Fault message "SRS - Service Required" displayed in instrument cluster and SRS lamp active

Topic number	LI54.18-P-069309
Version	3
Function group	54.18 Cable harnesses
Date	02-19-2019
Validity	Model series 177, model series 118, model series 247, model series 167
Reason for change	Model series validity adapted
Reason for block

AirbagModul.JPG:

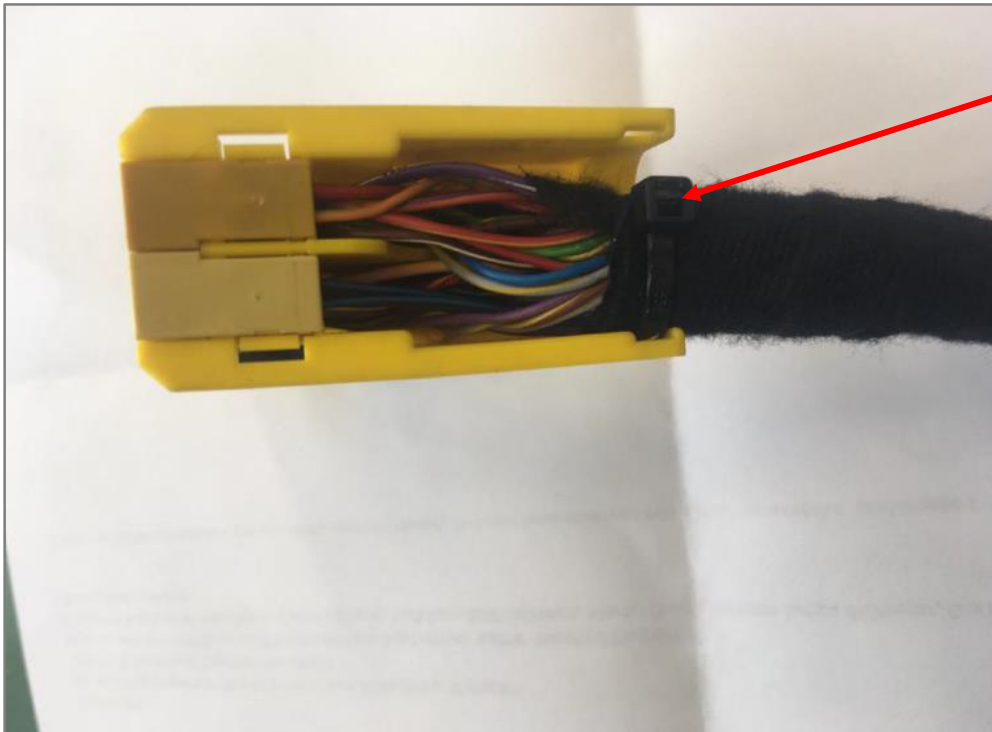
Some vehicles may have marks on the insulation of the electrical line at the K/Z airbag module, which are production-related tool locating marks.

The locating marks have no influence on the functioning. (See attachment)

New Construction Execution

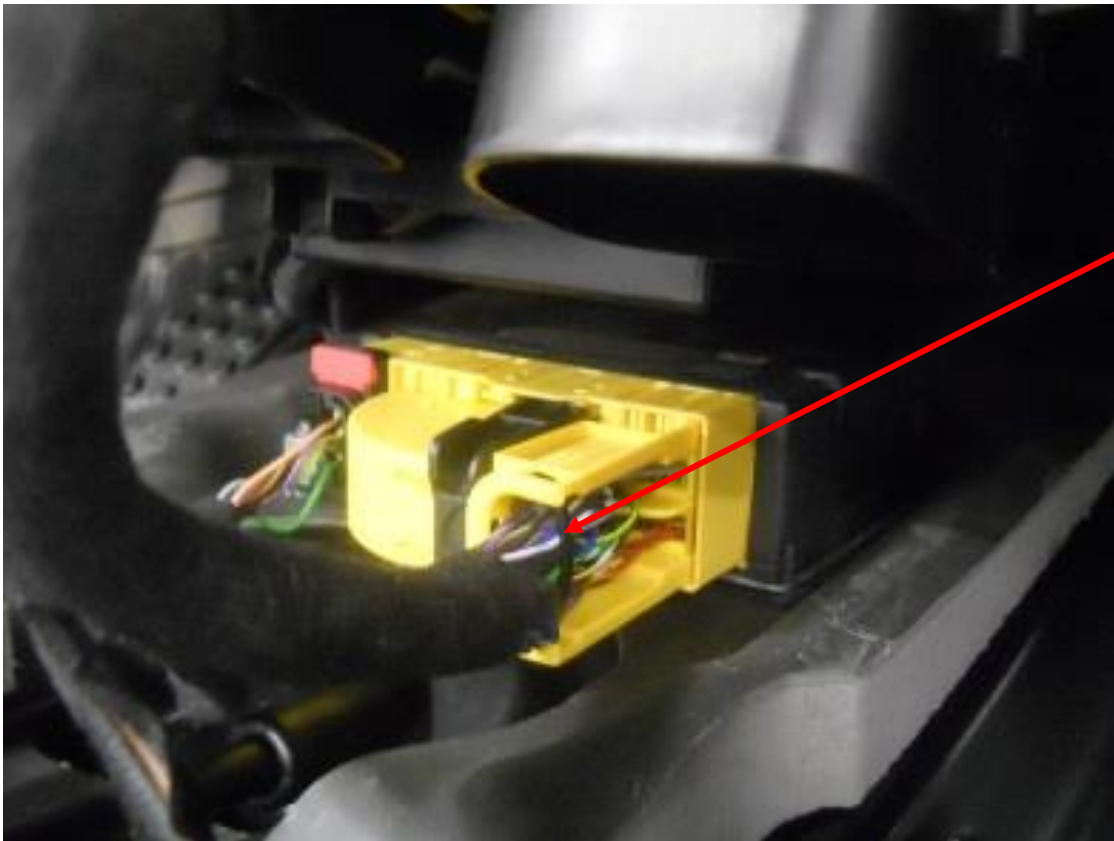
Current Verbaustatus

Wrapping Airbag SG u Cable Ties all MFA2 LL and RL

- All wraps should be wrapped between 1mm/ 5mm under the cable tie.
- cable ties

All BR LL and RL on the N2 / 5 control unit Airbag Full

- Wrapping ends 30mm before the start of the housing as shown in (Fig. 1)
- Cable tie (used for cable guidance.)
